Permit of Authorization to Construct an On-Site Sewage Facility Permit Valid For One Year From Date Issued

Permit Number: 118784
Issued This Date: 07/21/2025
This permit is hereby given to: JULIE ANNE CALHOUN

2301 RIMROCK DR
SPRING BRANCH, TX 78070

Thank you for your submission. We have reviewed the planning materials for the referenced permit application, and unfortunately, they are insufficient. To proceed with processing this permit, we require the following:

OWNER:	JULIE ANNE CALHOUN	DRAWN BY:	EJS III
STREET ADDRESS:	2301 RIMROCK DRIVE		
LEGAL DESC:	CYPRESS LAKE GARDENS - BIG SKY RANCHETTES	BLOCK:	202
		LOT:	13
PREPARED BY:	GREG W. JOHNSON, P.E. F#002585	SCALE:	1"=40'
		DATE:	6/25/2025
		REVISED:	6/26/2025

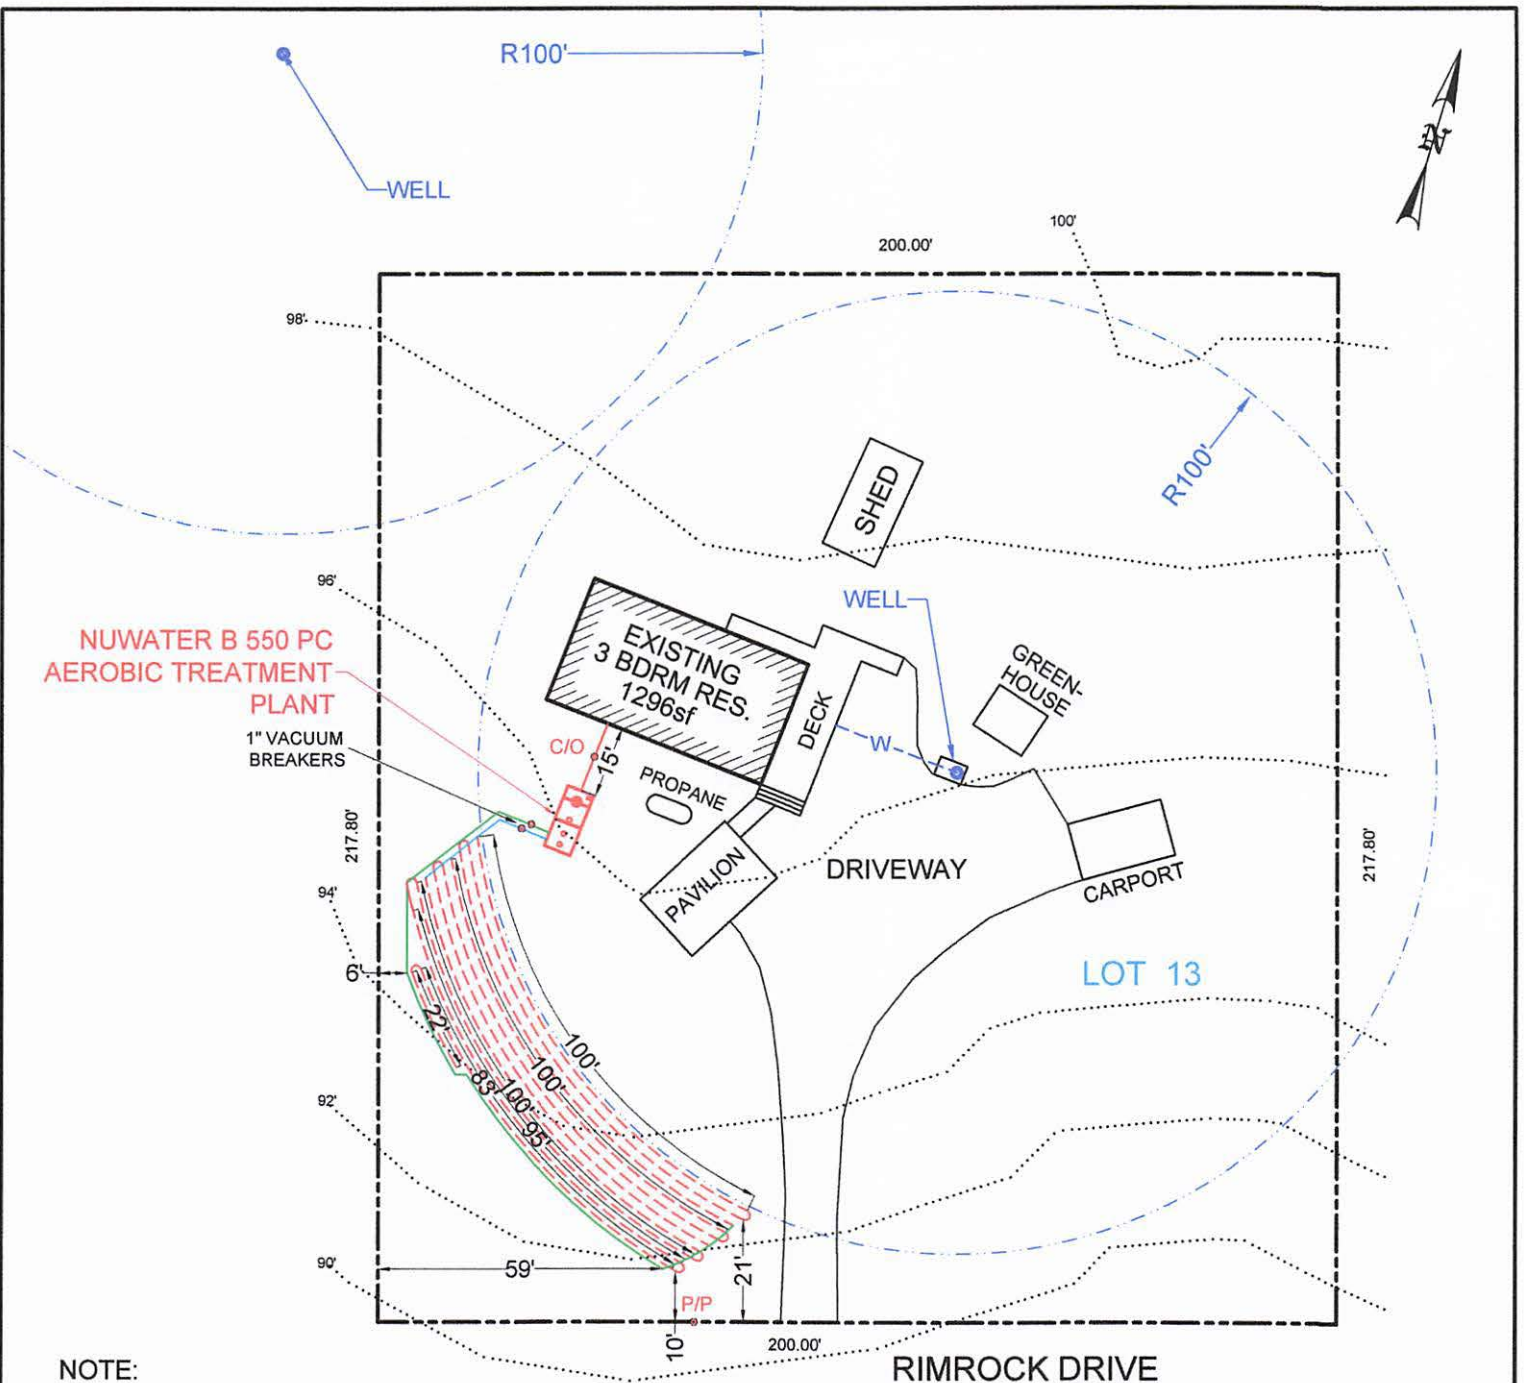
- ✓ Application page 1:
 - a. Source of water states public, site plan shows a well.
- ✓ OSSF Soil Evaluation Report Information page:
 - a. Existing or purposed water well in nearby area is marked no. Site plan show 2 wells nearby.
- ✓ Site Plan:
 - a. What is the separation distance from the OSSF and 560 Hillcrest Trl.?
 - i. Permit: [88294](#)
- 4. Revise accordingly and resubmit.

REVISED TO SHOW:
PRIVATE WELL ON APPLICATION & CALCULATION SHEET.
WELL ON 560 HILLCREST TRAIL > 100' FROM PROPERTY LINE.
THX,
GREG
